# Access Compliance Report

## Public Rights-of-Way

Intersection ID: 31839	Main Street: RUGGED_STONE_WY	Cross Street: SILVER_FALLS_WY	Location: NE
ADA ID: C8A134C62FE0	Ramp Type: Perp	Initial Pass/Fail: Fail	Overall Compliance: No
Severity Score: 13.75			
Codes/Mitigation Info/Possible Solution		Field Measurements/Component Compliance

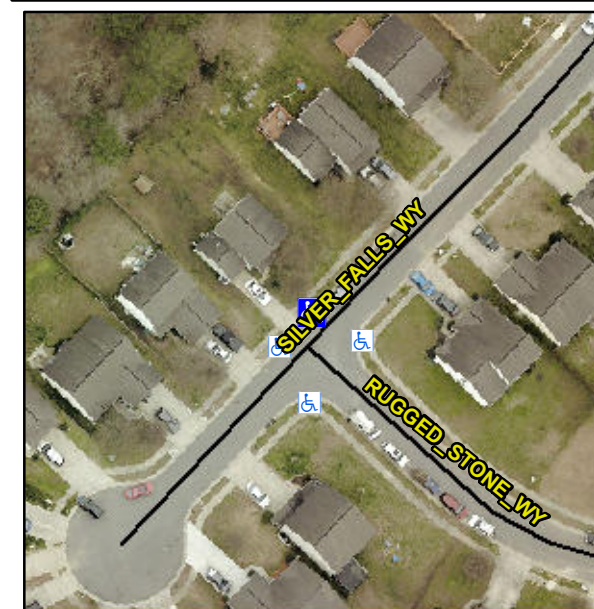
**Not Found, R304.2.2, R304.5.3**

Compliance	Description	Data	Compliance	Description	Data
N/A	Ramp Length (in)	46.0	No	Ramp Slope (%)	8.5
Yes	Ramp Width (in)	48.0	No	Ramp XSlope (%)	2.5
N/A	Flare Type LT	N/A	N/A	Flare Type RT	N/A
N/A	Flare Slope LT (%)	N/A	N/A	Flare Slope RT (%)	N/A
N/A	Flare Traversable LT?	N/A	N/A	Flare Traversable RT?	N/A
N/A	Landing Length (in)	N/A	N/A	DWS Provided?	N/A
N/A	Landing Width (in)	N/A	N/A	DWS Contrast?	N/A
N/A	Landing Slope (%)	N/A	N/A	DWS Length (in)	N/A
N/A	Landing X Slope (%)	N/A	N/A	DWS Full Width?	N/A
N/A	Landing Curb? (Y/N)	N/A	N/A	DWS Offset (in)	N/A
N/A	Shared Landing?	N/A			
N/A	Gutter Ponding?	N/A	N/A	Gutter Slope (%)	N/A
N/A	Gutter Lip Ht (in)	N/A	N/A	Gutter X Slope (%)	N/A
N/A	Painted X Walk1?	No	N/A	Painted X Walk2?	N/A
	X Walk 1 Direction	To SE		X Walk 2 Direction	N/A
N/A	X Walk 1 Width (in)	N/A	N/A	X Walk 2 Width (in)	N/A
	X Walk 1 Slope (%)	0.2		X Walk 2 Slope (%)	N/A
	X Walk 1 X Slope (%)	1.0		X Walk 2 X Slope (%)	N/A

**Remove & Replace Entire Ramp.**
